McLaren Speedtail - Clam and Harness Rework

Bulletin type:	Service Campaign
Reference number:	N/A
Campaign reference:	SCB 23 M 007
Attention:	Retailer Aftersales Managers, Retailer Service Managers, Retailer Service Advisors, Retailer Technicians, Retailer Parts Managers
Affected vehicles:	McLaren Speedtail
Situation:	Rear body clam and harness rework
Procedure:	Action affected vehicles on first opportunity (immediately if already on site or during next Retailer visit if not already on site). Please refer to the information outlined in this document to complete the required work
Date:	25 July 2024

Image 1 Rework Area

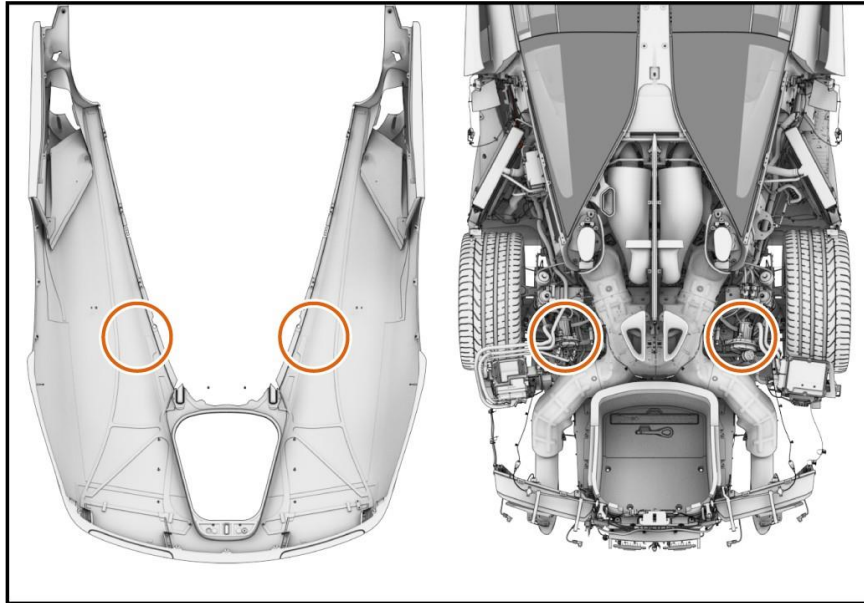
Through continuous product quality monitoring, McLaren Automotive has identified an opportunity to enhance the routing of the body harness in the engine bay area under the rear clam. The rework activity outlined below will eliminate the possibility for certain sections of the rear harness to clash with the underside of the rear body clam.
